**URGENT FIELD SAFETY NOTICE**

**FSCA Reference:** 1280465 – SPRINTER CART (XL) – Missing 'Pushing prohibited' label

**Affected Product:** INFUSION POLE (Mat. 701033599)  
SPRINTER CART (Mat. 701033456)  
SPRINTER CART XL (Mat. 701046022)  
SPRINTER CART (Mat. 701047813)  
SPRINTER CART XL (Mat. 701054184)

Figure 1: Figure showing Sprinter Cart system with Infusion Pole and indicating position of 'Pushing prohibited' label (see red marking)

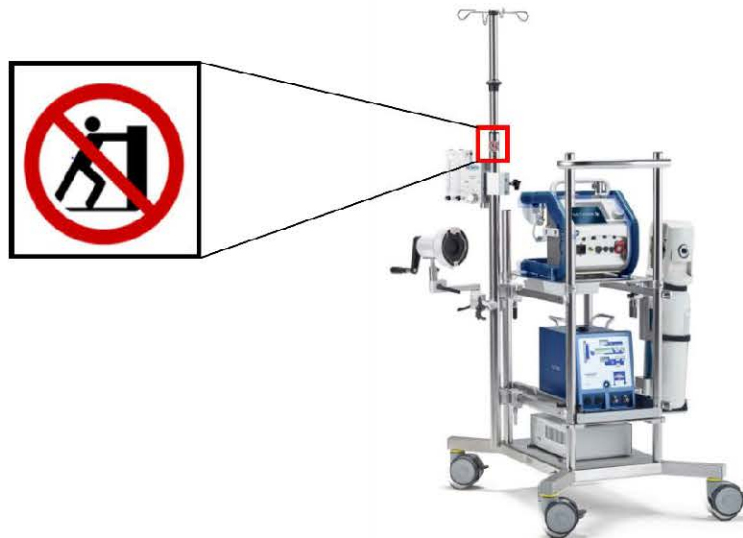
According to IEC 60601-1:2005+AMD1:2012+AMD2:2020, clause 9.4.2.3 'Instability from horizontal and vertical forces', if an equipment overbalances when being pushed/ leaned on/ etc. with 15% of its weight, the medical electrical equipment shall be marked with a clearly legible warning, e.g., safety sign according to ISO 7010-P017 (Figure 1).

Starting April 21, 2021, MCP implemented a safety sign on newly produced INFUSION POLES but did not correct INFUSION POLES manufactured before this date. Therefore, all INFUSION POLES manufactured before April 21, 2021, are affected by this issue.

- Corrective Action:**
- Verify presence of 'Pushing prohibited' label on each INFUSION POLE of SPRINTER CART/ SPRINTER CART XL **during next service visit**
  - If not present, affix 'Pushing prohibited' label to INFUSION POLE of SPRINTER CART/ SPRINTER CART XL **during next service visit**
